IN RE: PETITION FOR ZONING VARIANCE
E/S Washington Avenue, 155' S
of Chesapeake Avenue
(305 Washington Avenue)
9th Election District
4th Councilmanic District
305 Development Assoc. Ltd. Part.
Petitioners

BEFORE THE
DEPUTY ZONING COMMISSIONER
OF BALTIMORE COUNTY
Case No. 90-554-A

305 WASHINGTON AVENUE
OFFICE BUILDING
90-554-A
PETITION FOR ZONING VARIANCE TO REQUEST REDUCED AMENITY OPEN SPACE

SUBJECT: 305 Development Associates Limited Partnership
Item No. 413

drawing title
SITE PLAT
TO ACCOMPANY
ZONING PETITION

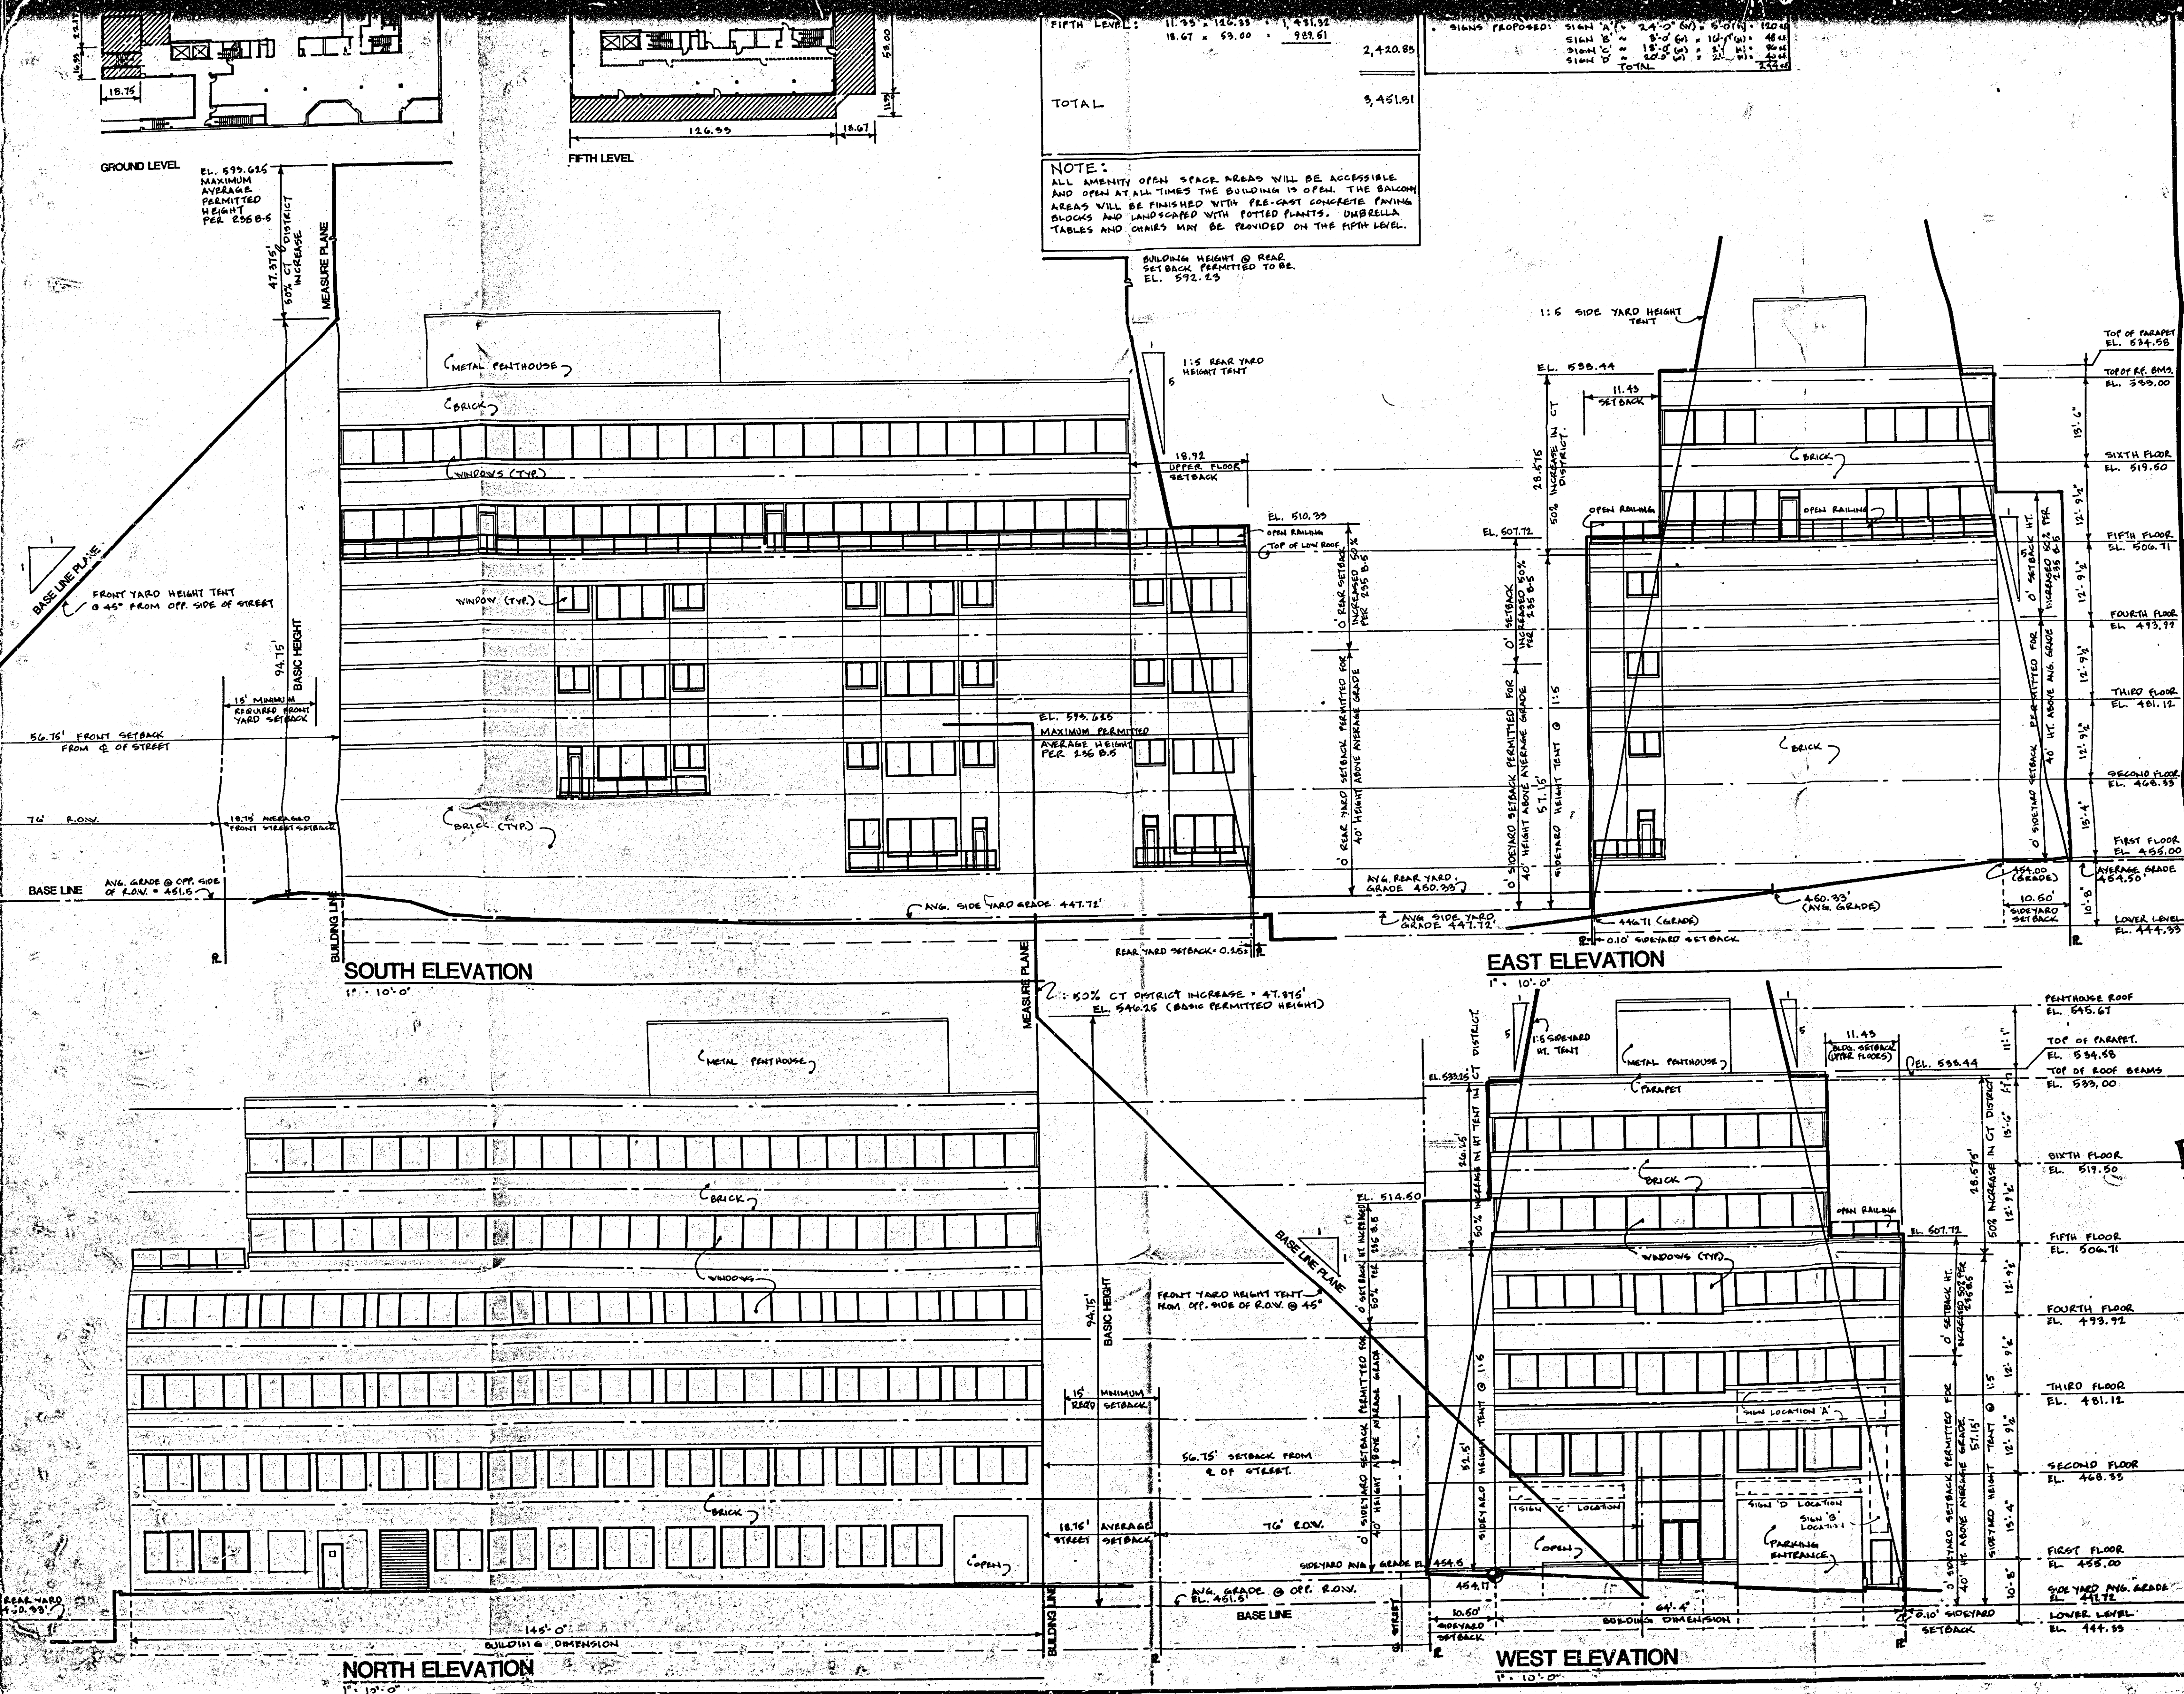
The Petitioners herein request a variance to permit amenity open space of 3,451 sq.ft. in lieu of the required 4,737 sq.ft., or an amenity open space ratio of 0.07285, in accordance with Petitioner's Exhibit 1.

The Petitioner requests a Variance to reduce the required amenity open space by 1,286 sq. ft. (from 4,737 sq. ft. to 3,451 sq. ft.) or a 27% reduction to provide an amenity open space ratio of 0.07285.

- The Petitioner's property received CRG approval on October 13, 1989.
- The subject request was necessitated by a change in the construction drawings that eliminated interior amenity open space in order to comply with BOCA requirements. An area that was open on the sides and useable as amenity open space at the rear of the building on the ground floor level is now enclosed and unsuitable for use. A building permit C-2399-89 for the office building was issued on April 12, 1990, based on site plans that met minimum amenity open space requirements. Construction on the building is under way.

drawing title
CRG ELEVATIONS

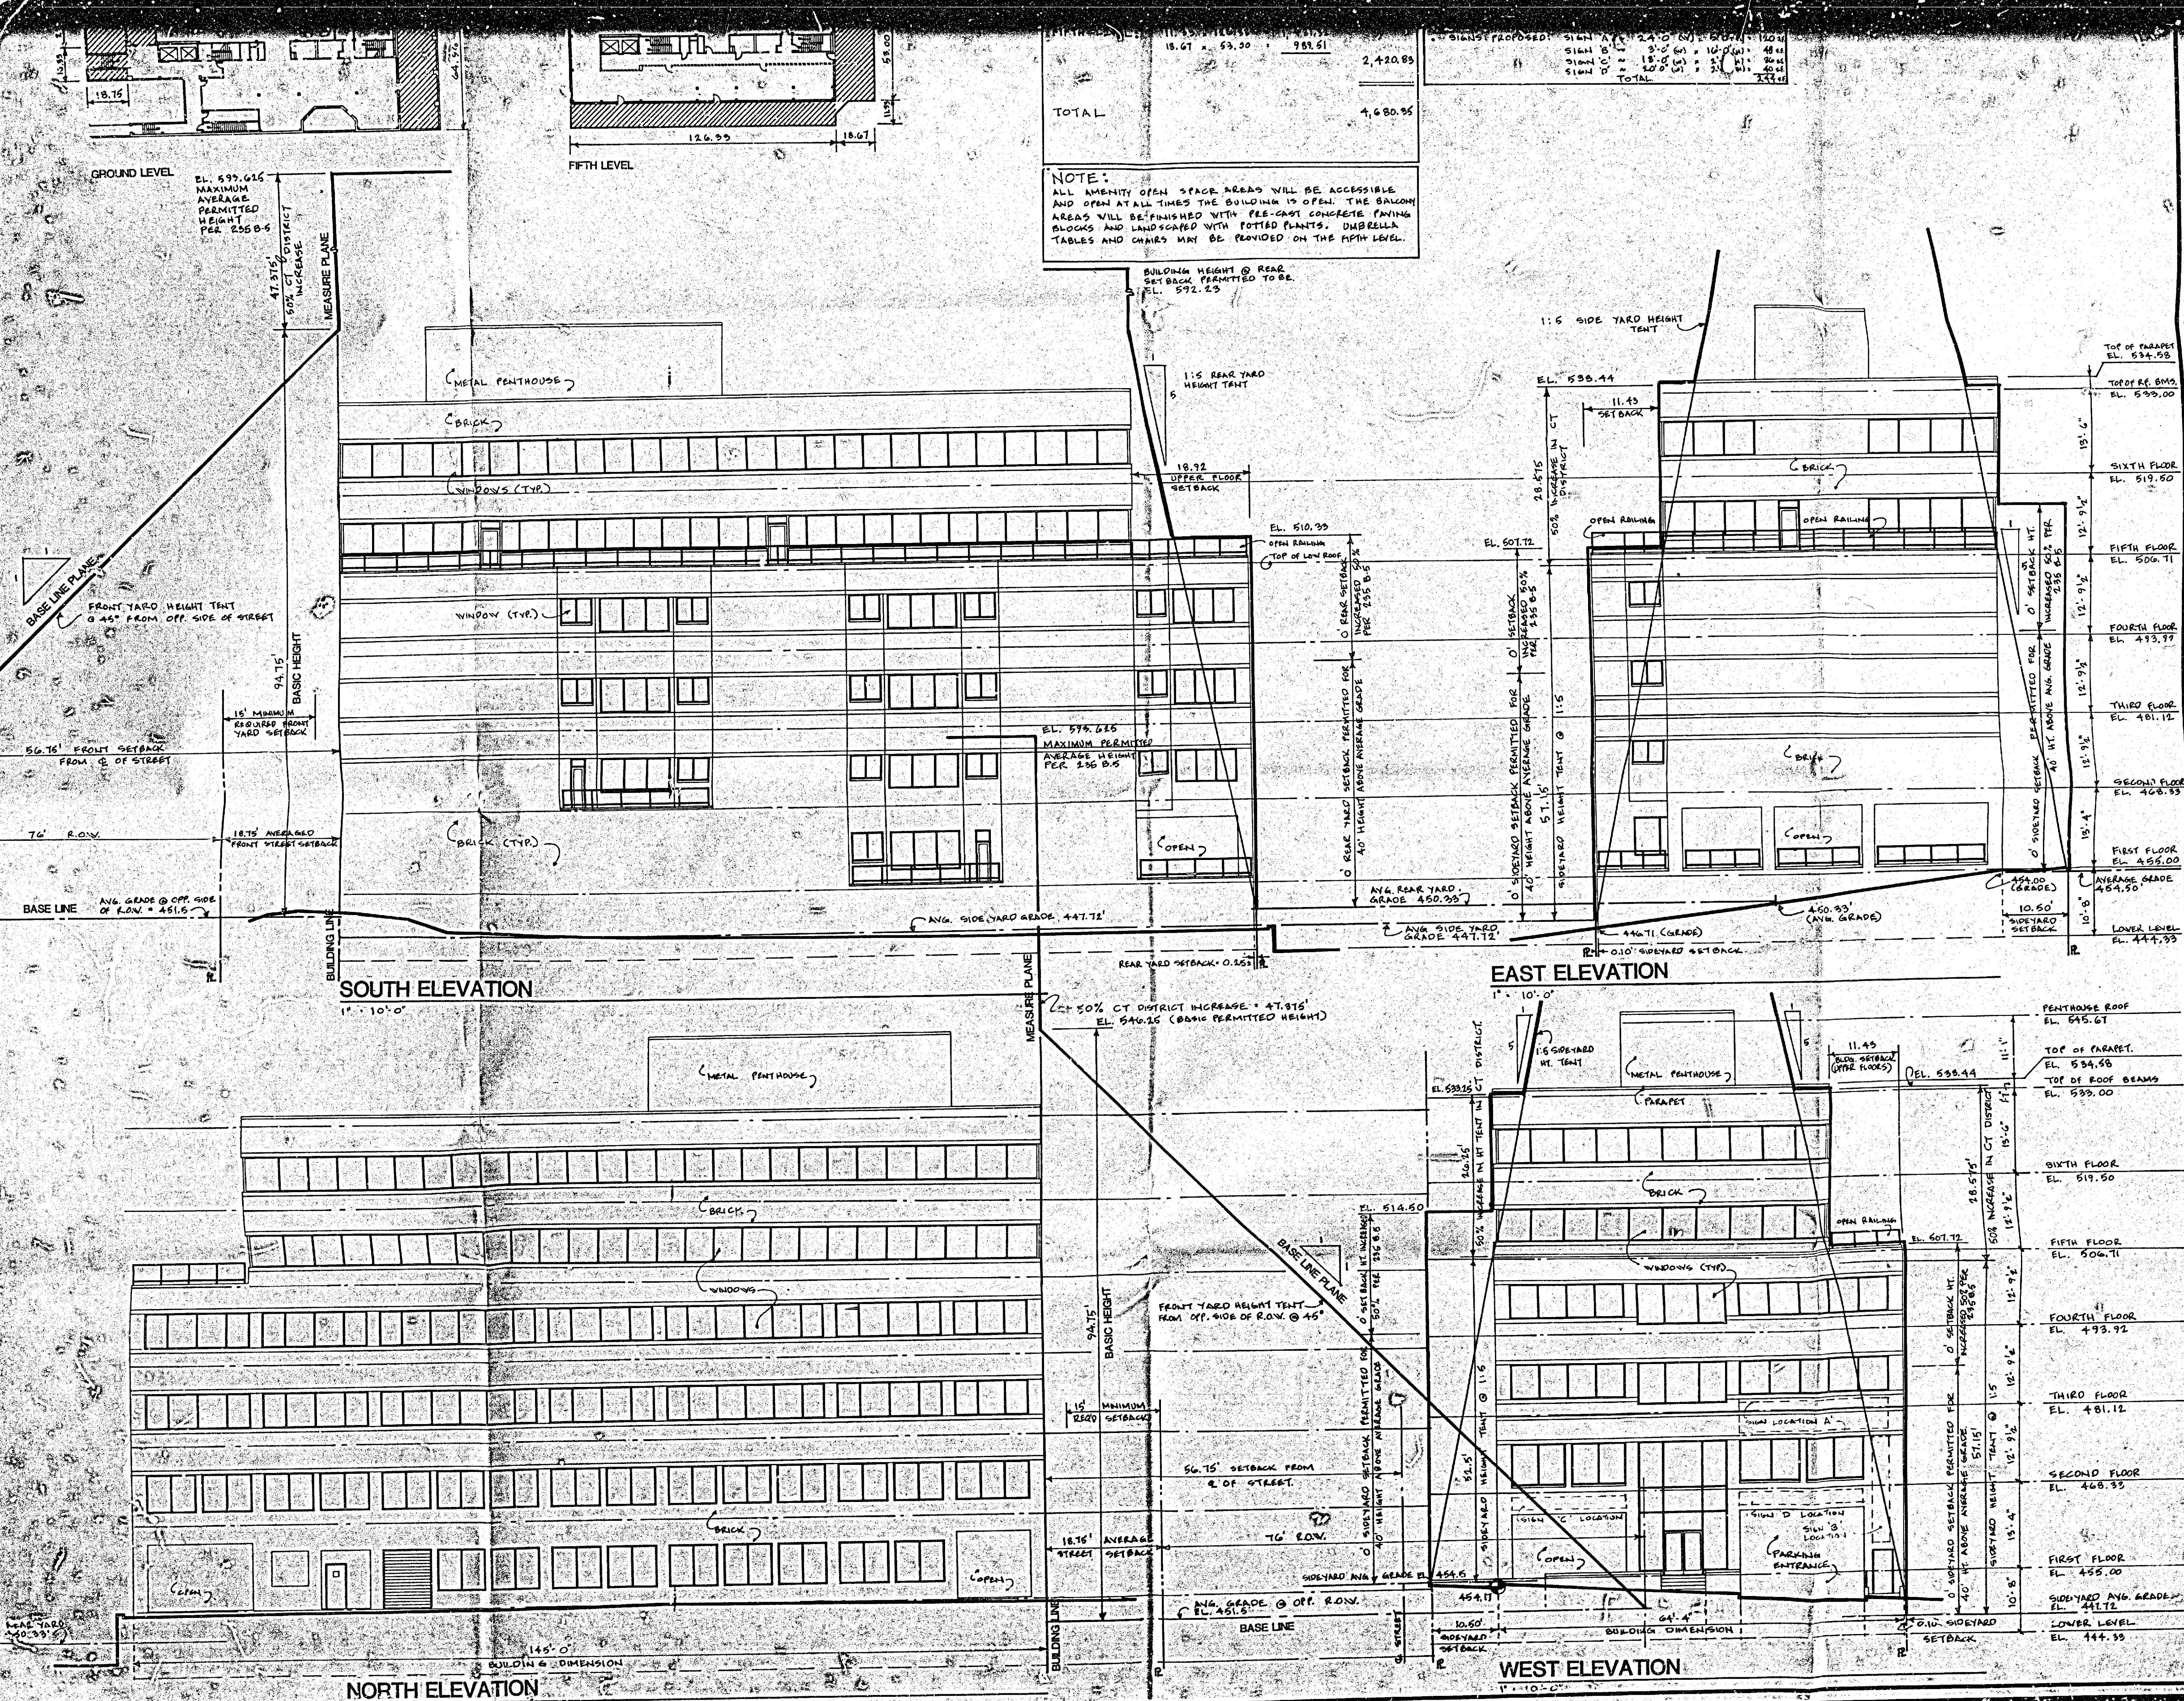
4. ~~1) 1 hour exterior wall is required by section 906.11 at the 1st floor east portion of the building.~~

5. Please show compliance with section 906.5 for North, South and East exposures with a fire separation distance less than 15 feet.

3. We will rate the enclosure walls as 2 hours for the Trash Room, and we have already specified a 3 label 1-1/2 hour door.
4. We will infill the openings at the first level of the East wall with masonry. This open space was created at the request of the Office of Current Planning and the Towson Development Corporation during the CRG process in order to create public amenity open space at the ground level. Obviously your insistence on this obtuse requirement will negate any opportunity to meaningfully respond to their request. We will, in fact, recommend to our client that he request a variance to the amenity open space requirement to create leaseable area therein.
